**Office of River Protection, State of Washington Department of Ecology  
Tank Waste Retrieval Work Plan/Functions and Requirements Change Notice  
(Per Hanford Federal Facility Agreement and Consent Order Section 9.3)**

<b>1. Document Title and Number:</b> RPP-22393, Rev. 6A, 241-C-102, 241-C-104, 241-C-107, 241-C-108 and 241-C-112 Tanks Waste Retrieval Work Plan		
<b>2. Minor Field Change:</b> (Section 12.4 HFFACO Action Plan)  <input type="checkbox"/> <b>Yes:</b> (WRPS Signature Only – Attach signed form to Primary Document for record purposes)  <input checked="" type="checkbox"/> <b>No:</b> Proceed to Box 3	<b>3. Document Issue Date:</b>  <div style="text-align: center;">05/21/12</div>	<b>5. Notice Number:</b> 2013-06
<b>4. Document Modification Notice Date:</b> 5/08/13		
<b>6.</b> Do proposed changes require schedule changes? (Would this extend completion of retrieval beyond 12 months from date of initiation?)  <input type="checkbox"/> <b>Yes</b> <input checked="" type="checkbox"/> <b>No</b>	<b>7.</b> Do proposed changes include specific additions, deletions, or modification to scope and/or requirements which affect the overall intent of the plan?  <input type="checkbox"/> <b

**Figure 4-2. Waste Management Area C and Regulated Structures.\*^**

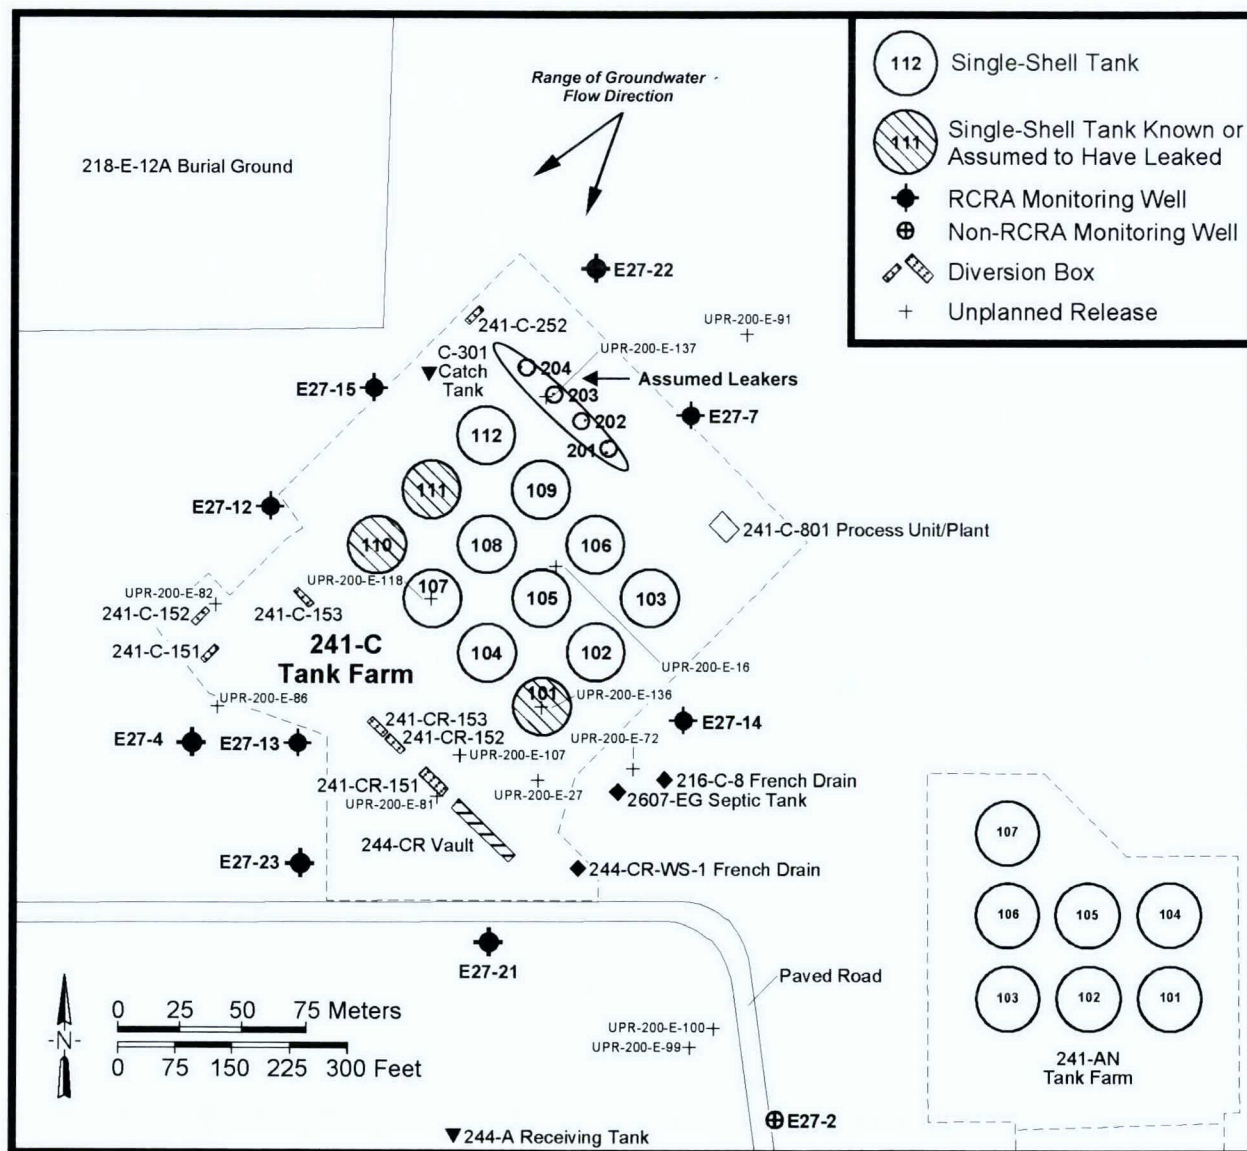
^The most current list of groundwater monitoring wells can be found in DOE/RL-2009-77
